**Ivas Environmental
Environmental Sciences
Wetlands and Planning Services**

**City of Boston Conservation Commission
Boston City Hall
1 City Hall Square
Boston MA 02201**

RE: MA DEP File #: NE - 006-1816, 155 Porter Street, East Boston

This letter covers the attached package of information provided to the City of Boston Conservation Commission. It is written as a response to Mr. Moreno's comments of 03 Nov 21 regarding the proposed project at 155 Porter Street.

1 BUILDING SECTION
A-301 3/32" = 1'-0"

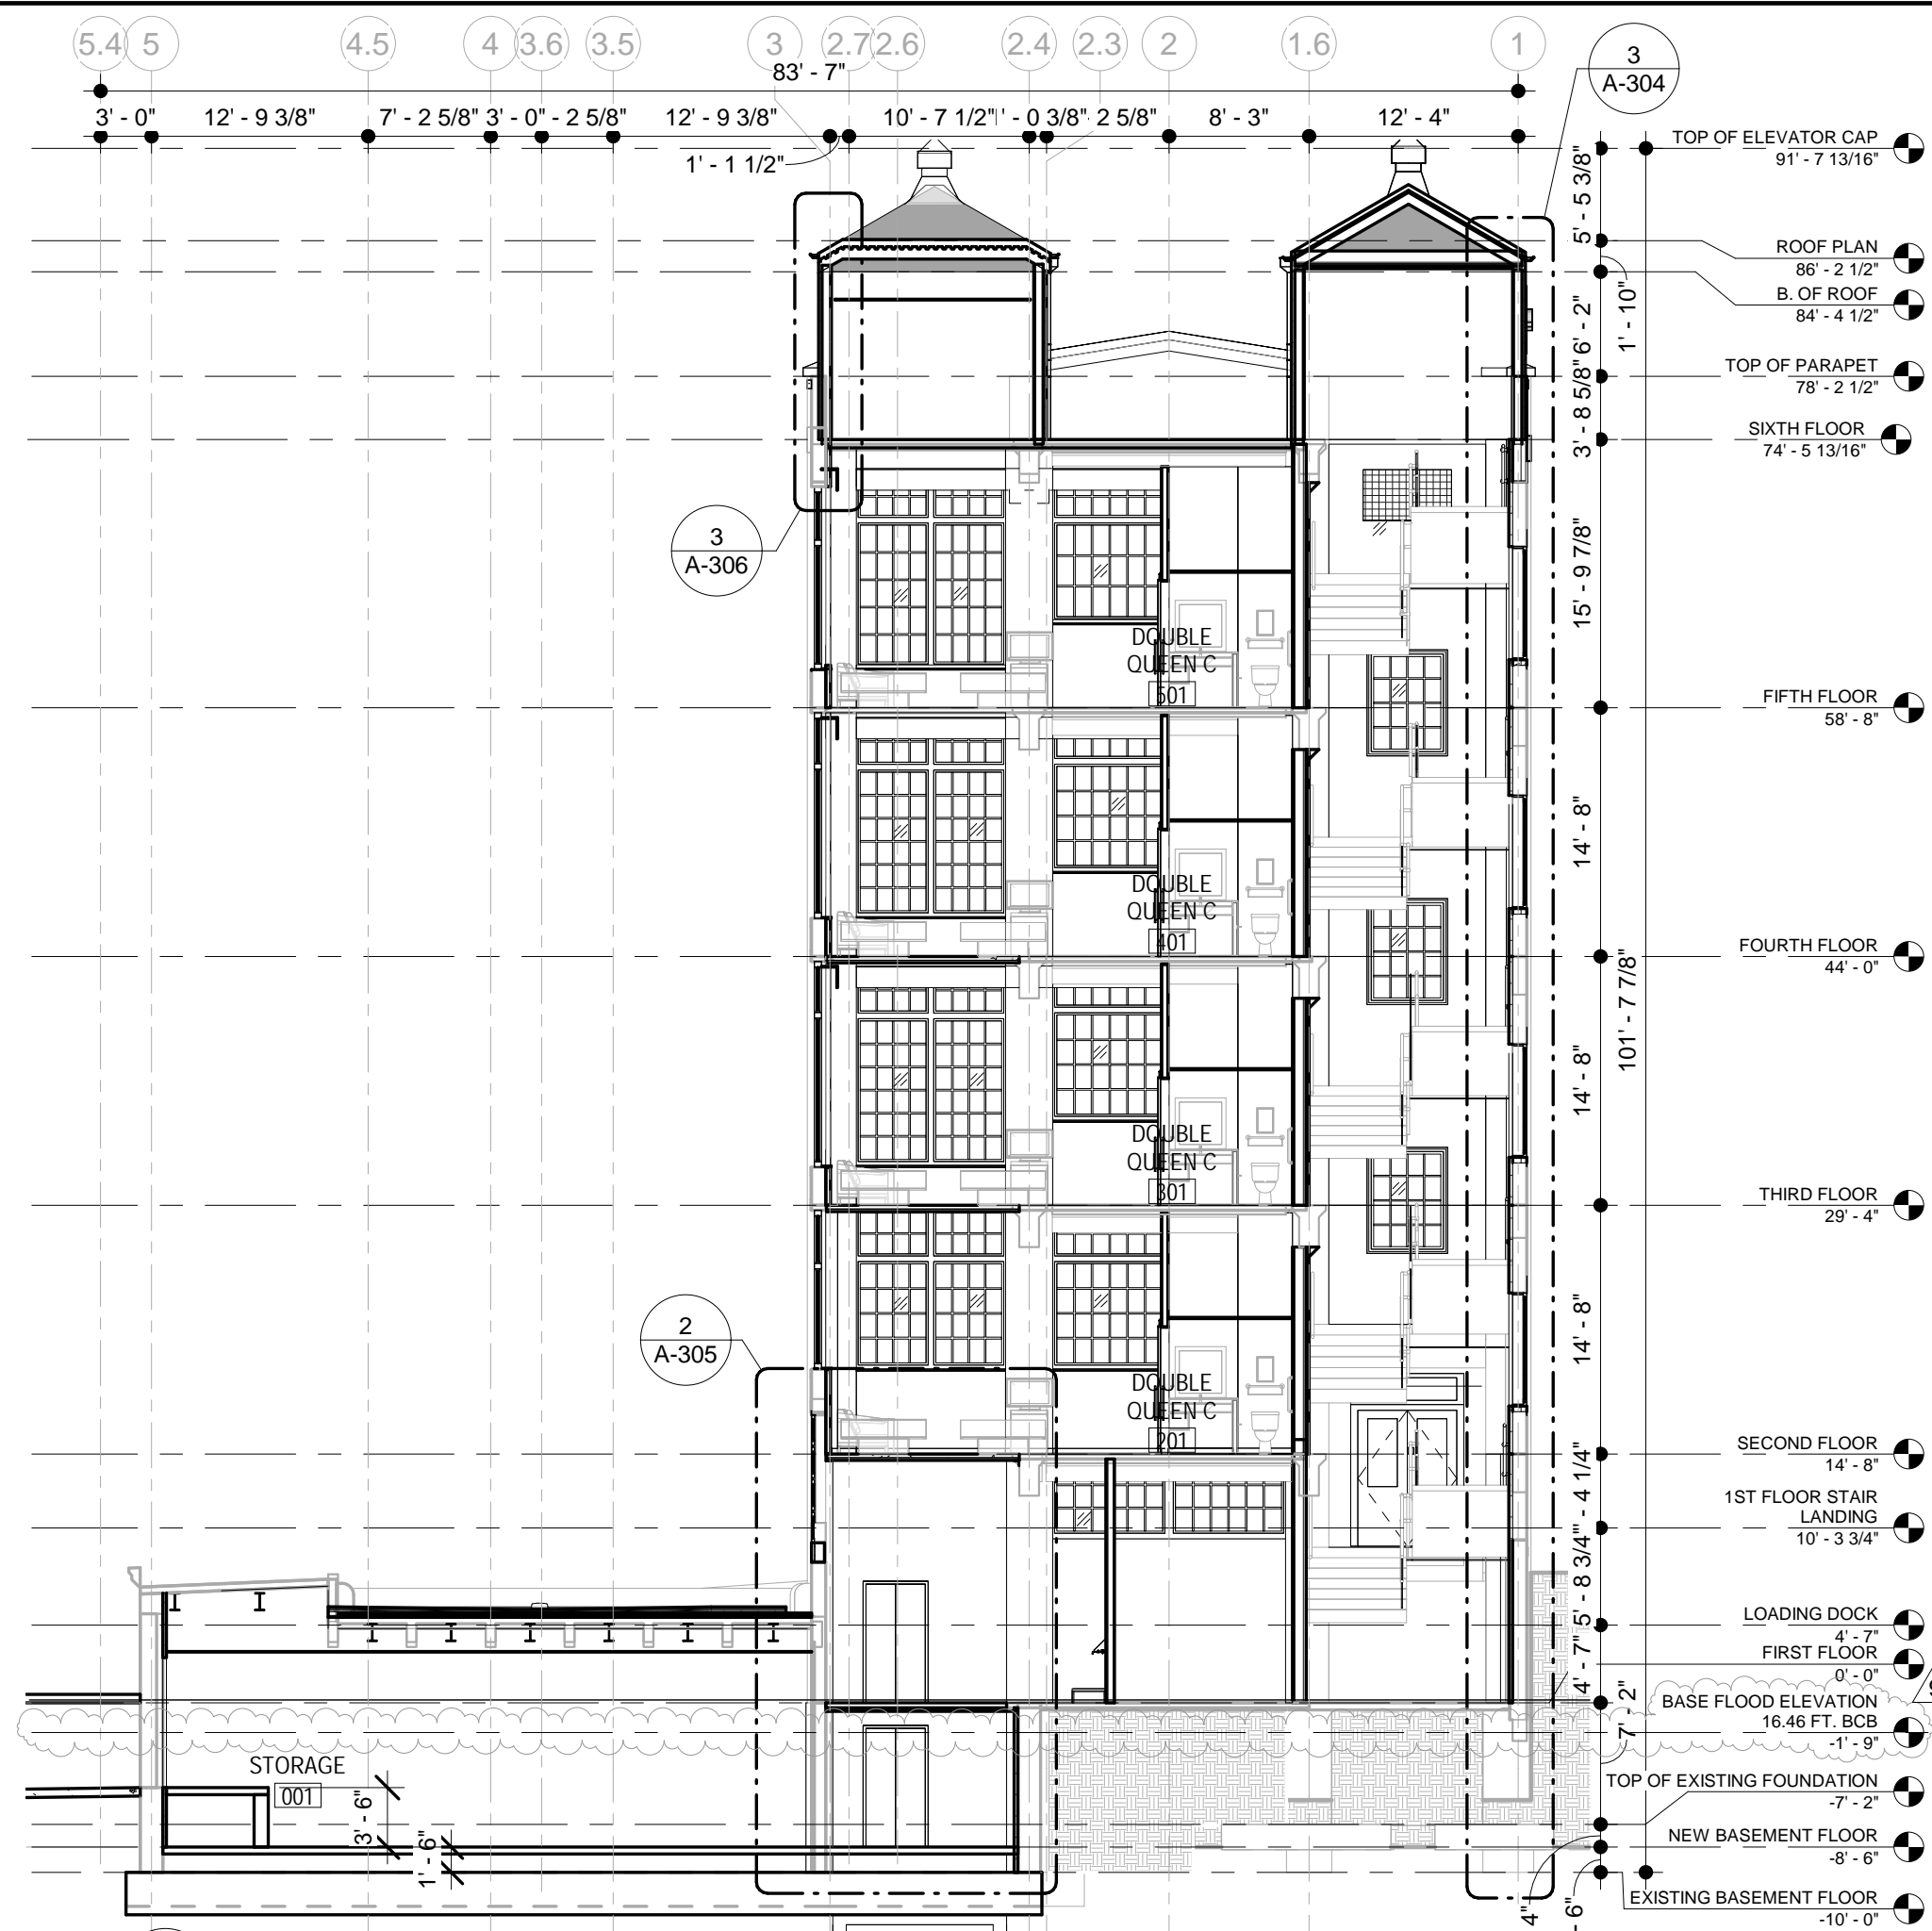
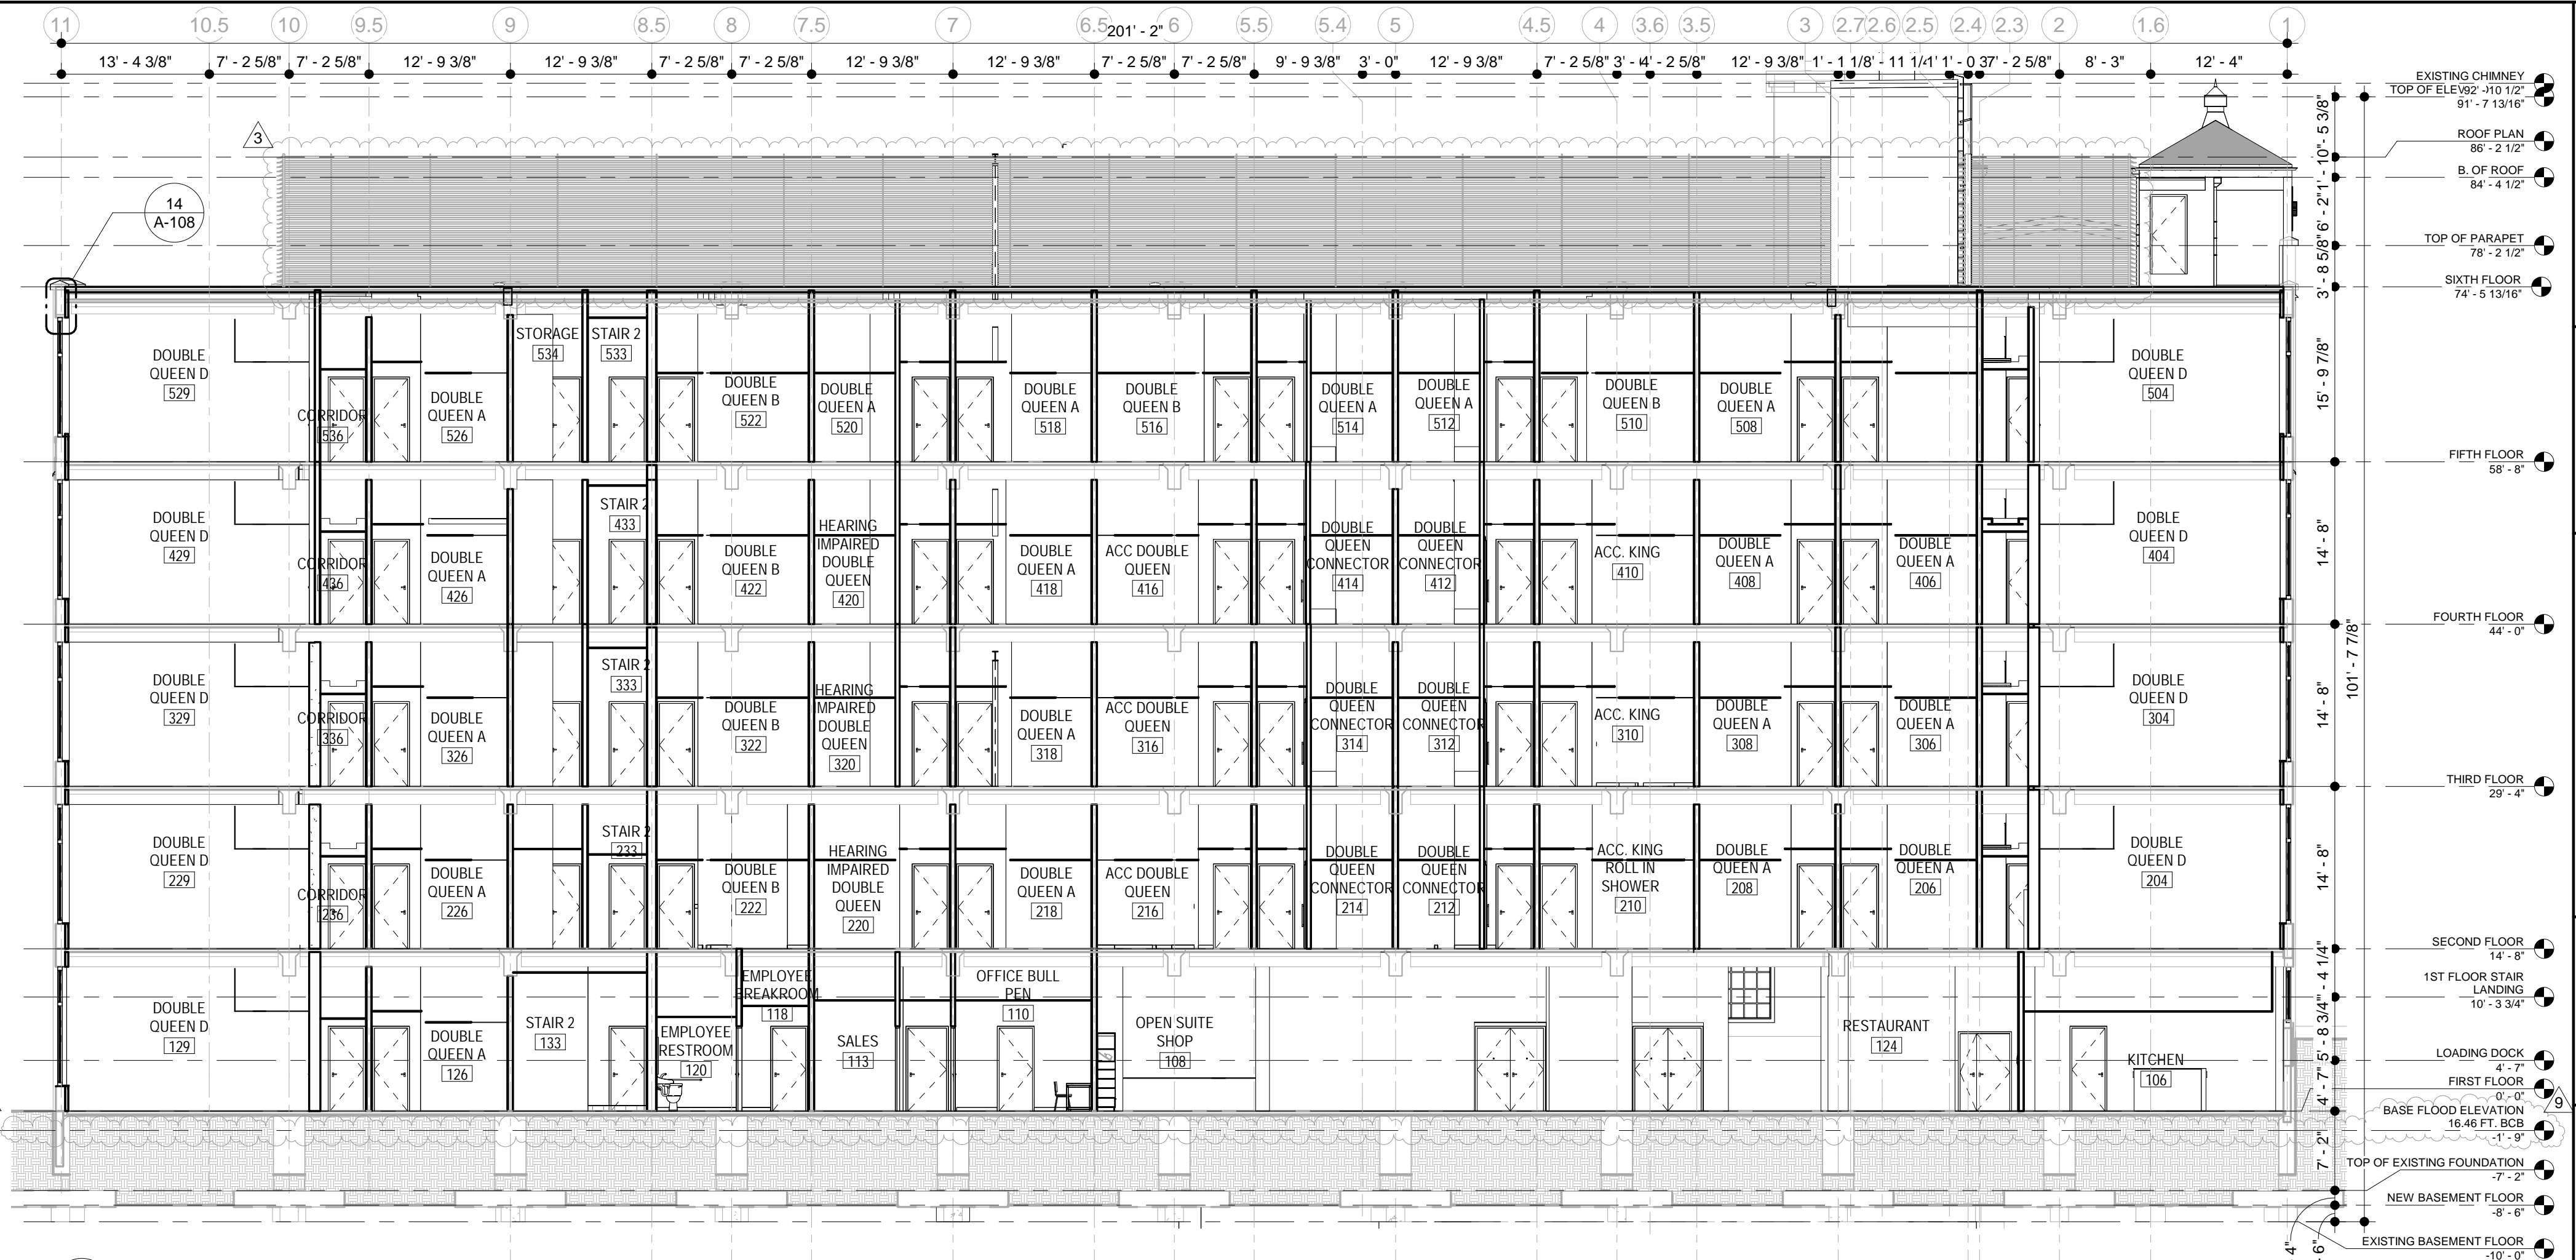
8. Please also include the base flood elevation line on the building section plans.

The base flood elevation has been provided on the building section plans attached.
